SERVICE BULLETIN

Model: GEN5.0, Spec: PA-GEN50-3003 Only

Subject: Wiring Discrepancy Fix

Notice - Risk of Electrical Shock - Mandatory Product Update

Figure 3 Current Jumper Cable Position

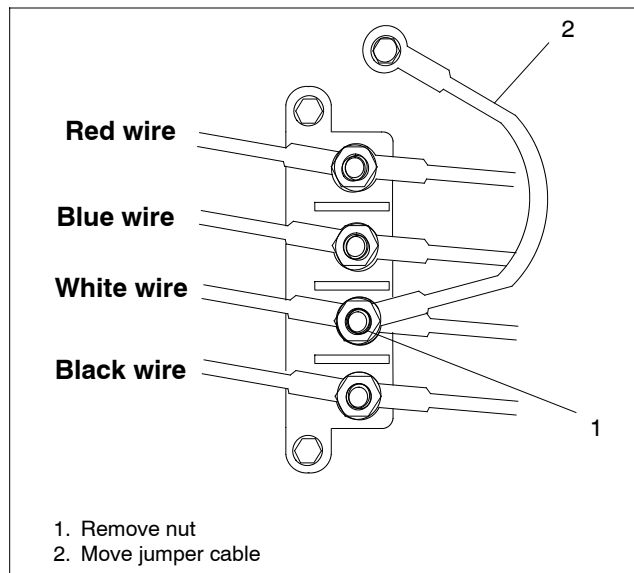
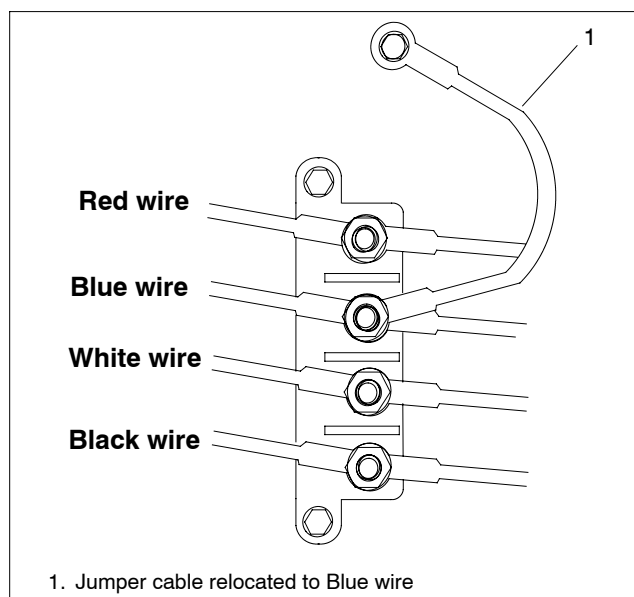
Kohler Power Systems is issuing a recall on Kohler portable generator sets manufactured between January 8, 2016 and January 26, 2016. This recall is to correct an error in the generator set 120 Volt electrical wiring. This incorrect wiring can, under certain conditions, result in the "Neutral" contact in the receptacle to become "Hot" or "Live" with respect to ground. This wiring error increases the risk of electrical shock in the event an unprotected electrical device is plugged into the generator set. GEN5.0 generator sets with Specification PA-GEN50-3003 manufactured before serial number 4602131185 are affected.

The solution is to modify the position of the white jumper cable.

5. Using the 8mm socket, remove the nut holding the white jumper cable terminal in place. See Figure 3.

6. Remove the jumper end from the terminal, and reinstall the flat washer, then the split washer, and then the nut using the 8mm socket. Torque nuts to 5.8 Nm (51 in. lbs.).
7. Remove the nut, split washer, and flat washer from the blue wire terminal.
8. Install the white jumper cable end to the terminal of the blue wires.
9. Install the flat washer, split washer, and then the nut using the 8mm socket. See Figure 4. Torque nuts to 5.8 Nm (51 in. lbs.).

Figure 4 Modified Wiring

Figure 5 Red Circle Decal Location

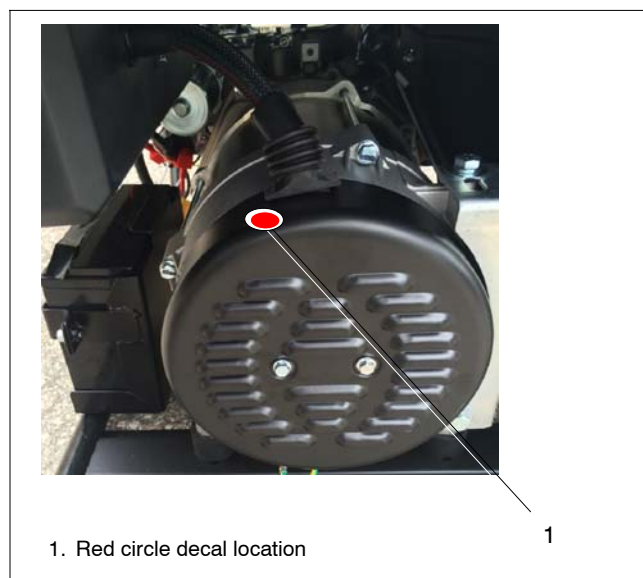
11. Install the 2 screws to hold the cover in place using the 8mm socket. See Figure 5.
Torque screws to 4 Nm (35 in. lbs.).
12. Affix one red circle decal, included with the service bulletin mailing, to the top of the rear cover. See Figure 5 for location.
